## M2 Plus Crew Cab Dome Light Not Activating With Rear Doors

***Field Service Solution SS 3153-FTL***

***Published Date: 09/13/24***

### Dash Wiring Changes

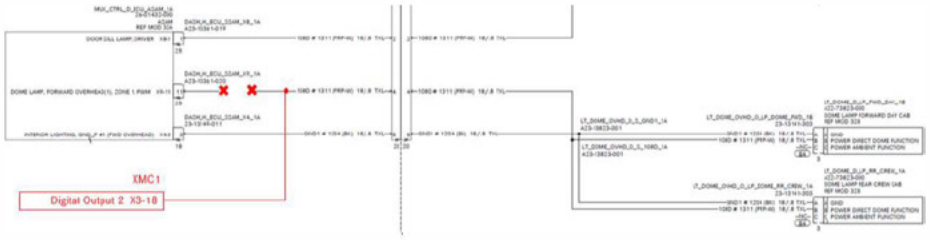
- The dome light in the cab does activate if either of the front doors are opened. The issue is only with the M2 Plus Crew Cab and the rear doors not activating the dome lamp when opened. This service solution **SS 3153-FTL** provides a fix using an XMC1 to route the signal to the dome lamp.

**Note:** It should be OK to splice 108D circuit into existing TEM dome light output if XMC pin already populated for TEM connector. This output pin can supply enough current for multiple loads (20A) .
If a terminal is not present at X3-18 then use terminal P/N AI 1 968849 1 (23-13209-202) that will fit an 18 GA TXL wire. If for some reason a larger wire is used such as a 14 or 16 GA TXL wire, then use terminal P/N AI 1 968873 1 (23-13209-200).

- Published Service Solution **SS 3153-FTL** on **9/13/24** that provides technician guidance for modifying the wiring and adding programming to the XMC1 that corrects for the issue.
